SERVICE ALERT

NO.: 0936 Revision B

SUBJECT: Navigation error condition concerning terminal procedures with Direct-to-Fix (DF) legs

Figure 2. GNS 400W/500W Series Display While on Second DF Leg

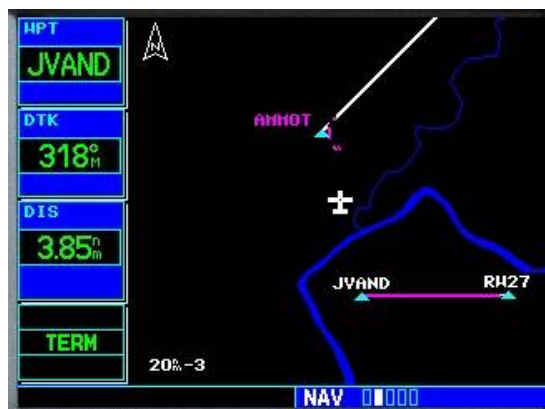
If this condition is experienced, the following indications may appear (refer to Figure 1 and Figure 2 for examples):

- a) Waypoint alerts are not provided at the waypoint prior to the automatic Direct-to-fix leg.
- b) The selected course, desired track, and CDI provide guidance to a non-published course. The non-published course may be depicted by Pathways (if equipped), but is NOT displayed on the navigation map.
- c) The previous leg of the flight plan remains shown as a magenta line on the navigation map, though it is no longer the active leg.
- d) On the GNS 400W/500W series, the previous waypoint of the flight plan is incorrectly displayed as the active waypoint.

Figures 1 and 2 show the magenta course line behind the aircraft position.

Do not rely on automatic sequencing of Direct-to-fix waypoints. Do not delete an active Direct-to waypoint from the flight plan. If any of the above indications occur at any time, stay on the published course using back-up navigation techniques and manually activate a Direct-to leg using the Direct-to button () to the appropriate published waypoint in the published terminal procedure.

400W/500W Series Main Software version 3.30 corrected this issue as described in Garmin Software Service Bulletin 0918 Revision A.
